**Millennium Coal Mine EPML00819213
Environmental Authority amendment
Information Request Response**

17 February 2025

The Information Request (IR) response provided in **Table 3-1** below is based on the MetRes EA EPML00819213 amendment submission received by the Department of Environment, Tourism, Science and Innovation (DETSI) on 19/06/2024 [Department reference: application number C-EA-100673441].

FIGURE 6

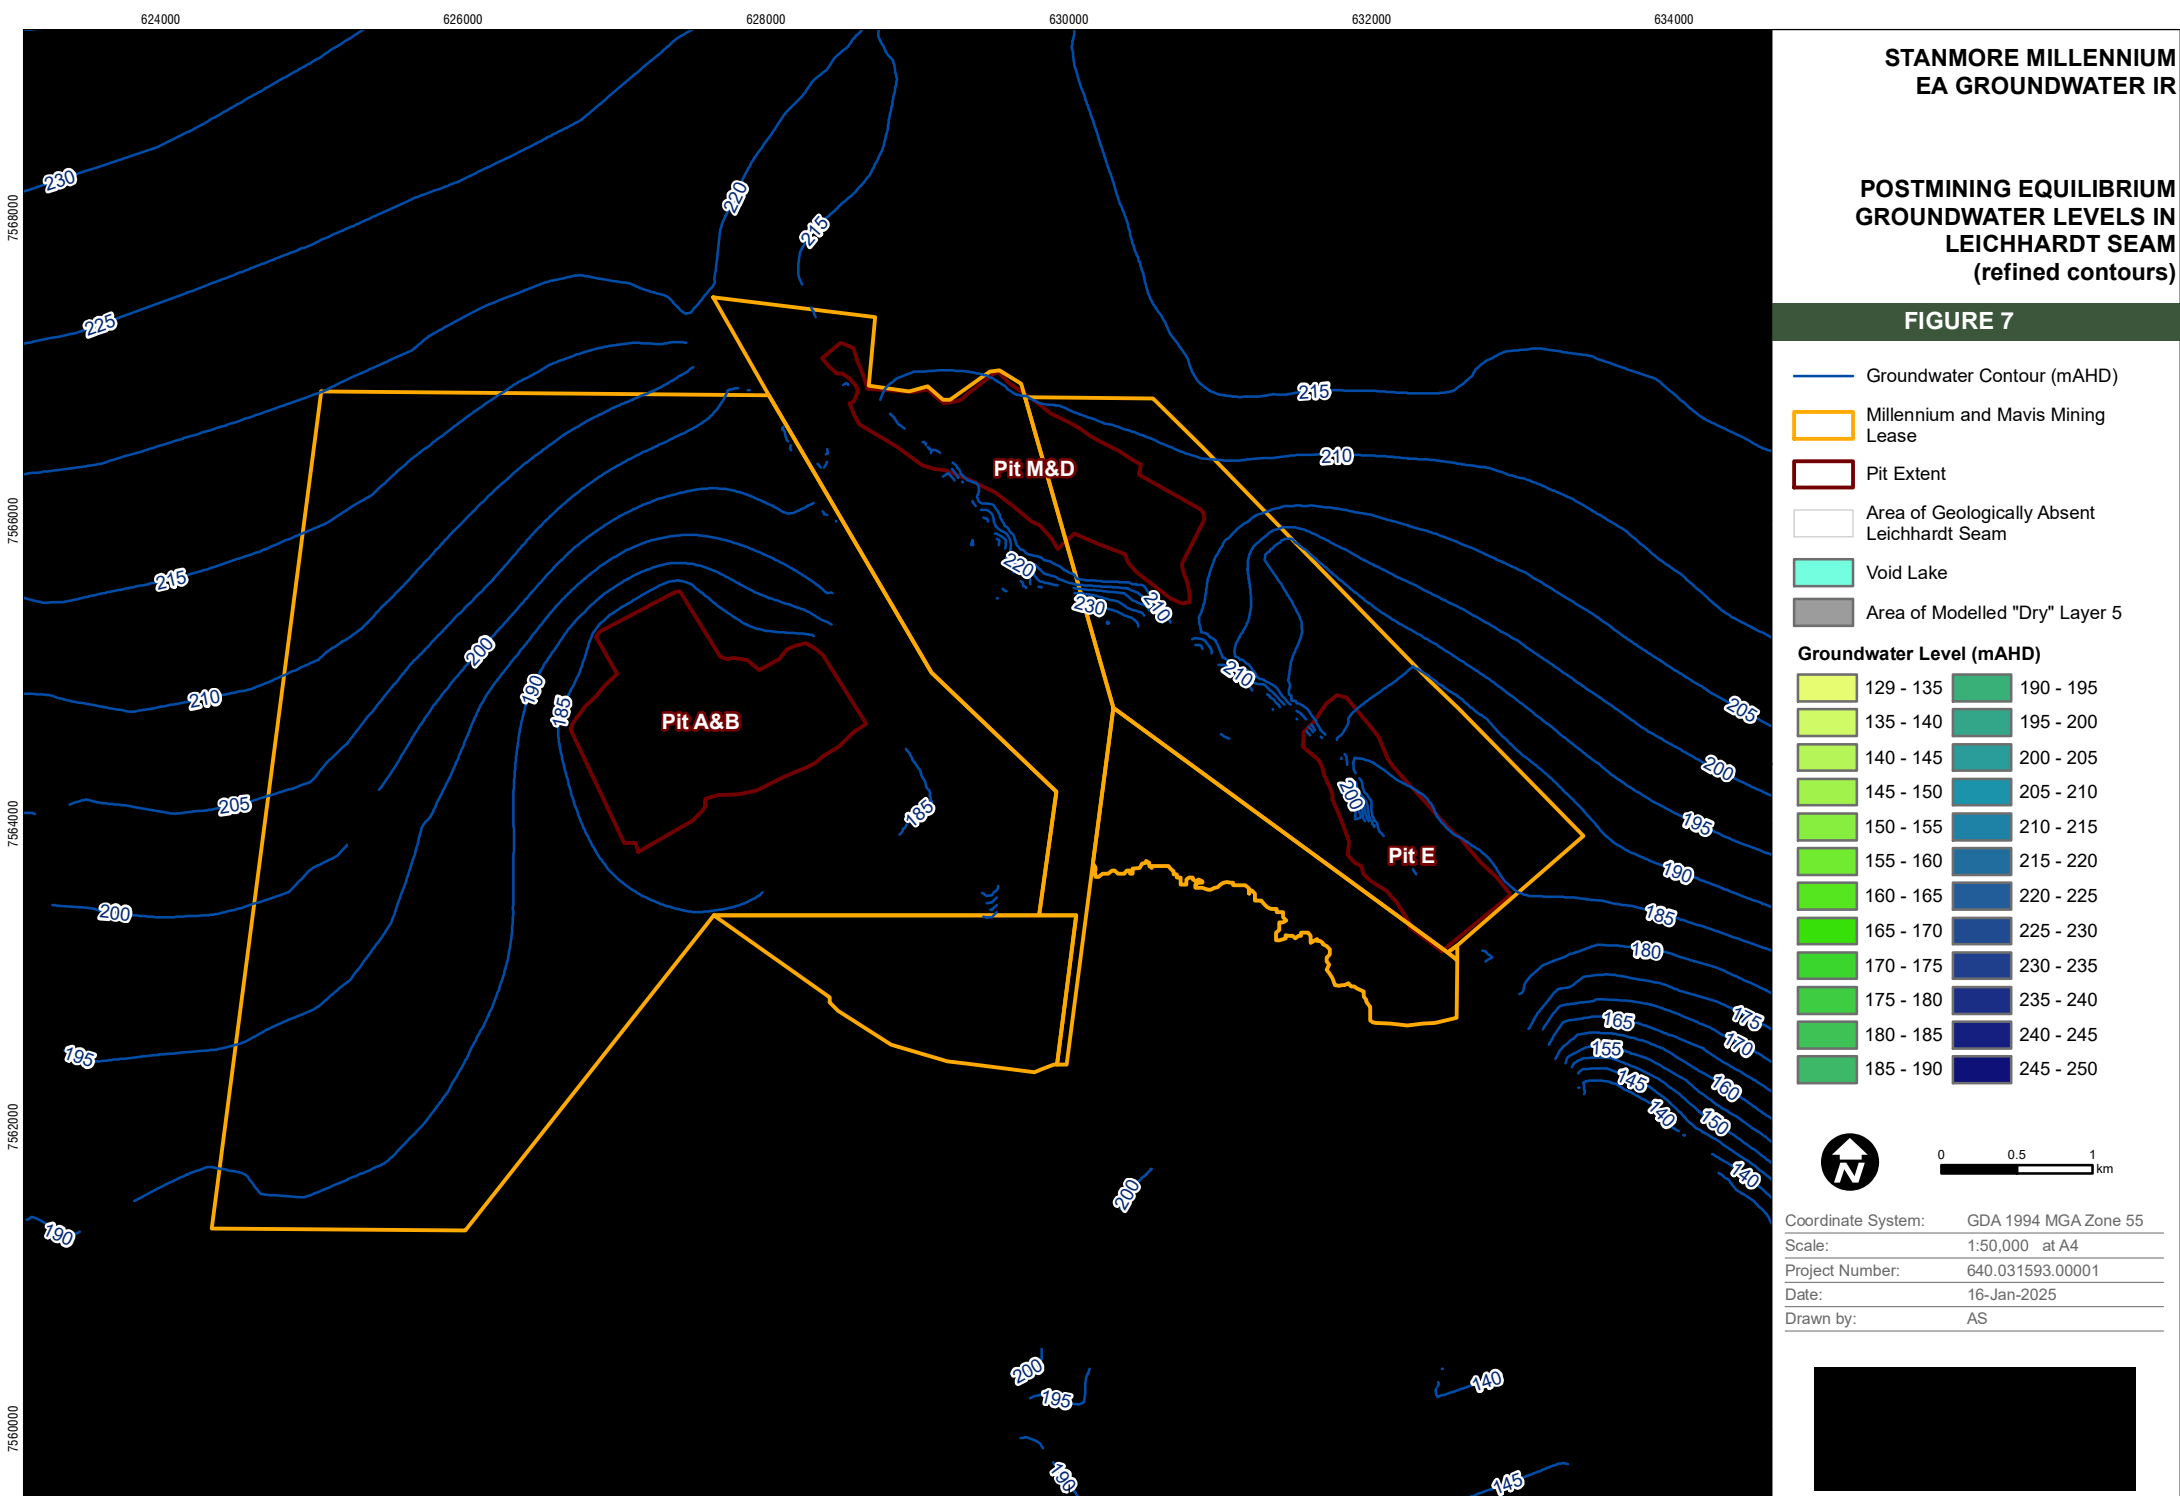
12	<p>Void Water interaction – Interaction of void water with surrounding aquifers Provide the following:</p> <ol style="list-style-type: none"> a) More detailed groundwater elevation contours for Figures 6-10, 6-11 and 6-12. b) Additional contours for the Rewan Formation, to better understand potential groundwater flow directions off lease. c) Advice as to how potential contaminants in groundwater can be stopped from leaving the mining lease area. 	<ul style="list-style-type: none"> • Groundwater elevation contours for post-mining equilibrium water table, Leichardt seam, and Vermont Seam have been provided in Figures 6, 7 and 8 with greater contour resolution. • Figure 9 provides groundwater contours for the Rewan Formation. • Discussion pertaining to movement of potential contaminants in groundwater from the mining lease area has been provided. • 	1.9
13	<p>Groundwater Exceedances, Condition D4.0 Provide the following:</p> <ol style="list-style-type: none"> a) If the three (3) exceedances condition is to be adopted for all bores and all parameters, provide more groundwater monitoring data for the bores which do not currently have 	<p>IRIRA review of the entire network trigger levels has been undertaken to support this item. This occurred in conjunction with the investigation for the following as requested:</p> <ul style="list-style-type: none"> • MB9A: Molybdenum 	1.10

- a) Please see amended Figures (here as **Figure 6**, **Figure 7** and **Figure 8**) provided below with groundwater contours refined my 10 metres to 5 metres .
- b) Please see additional figure, **Figure 9**, below for Rewan Formation.
- c) The particle tracking methodology was set up to place particles in the middle of the first saturated water column in the model. Refer to Figure 6-13 of the PRCP Appendix G for location and layer of the starting points.

Figure 11 MB9A – Aluminium data and trend analysis

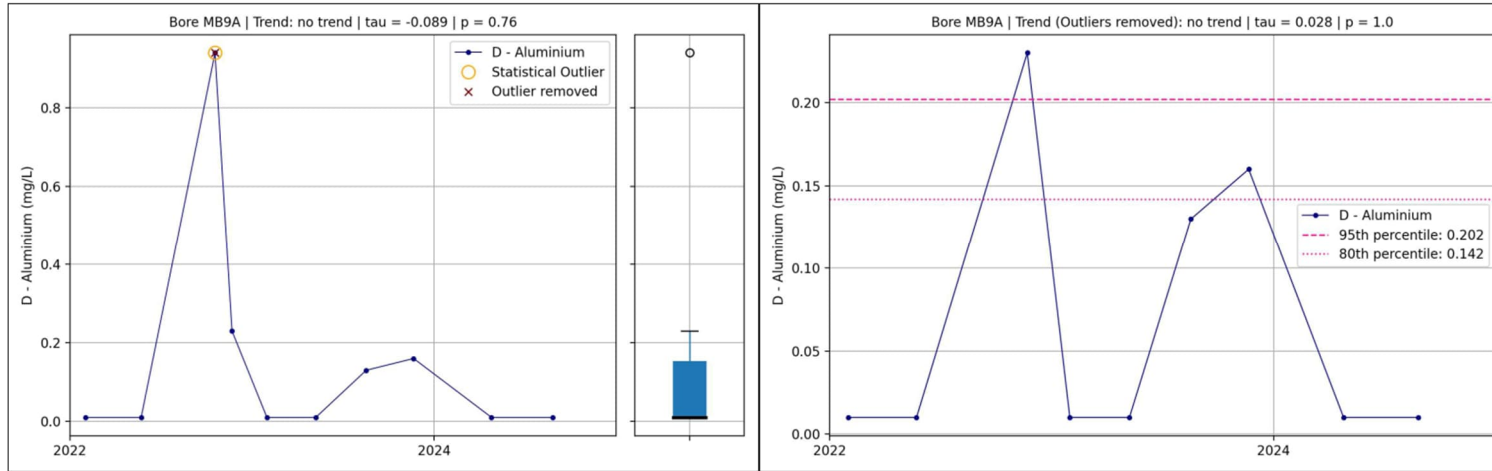
- If the three (3) exceedances condition is to be adopted for all bores and all parameters, provide more groundwater monitoring data for the bores which do not currently have sufficient data points to allow derivation of bore specific values.
- Confirm if agree to maintain default guideline values and relevant trigger exceedance limit as per current Condition D4.0 for bores which do not have sufficient data to derive bore specific limits
- Explain the increasing Aluminium trends in bores MB9A and MB9B

- c) The apparent observed increasing Aluminium trends in bores MB9A and MB9B, noted as two points trending upwards in late 2023, has since ceased, with stable parameters observed in 2024.
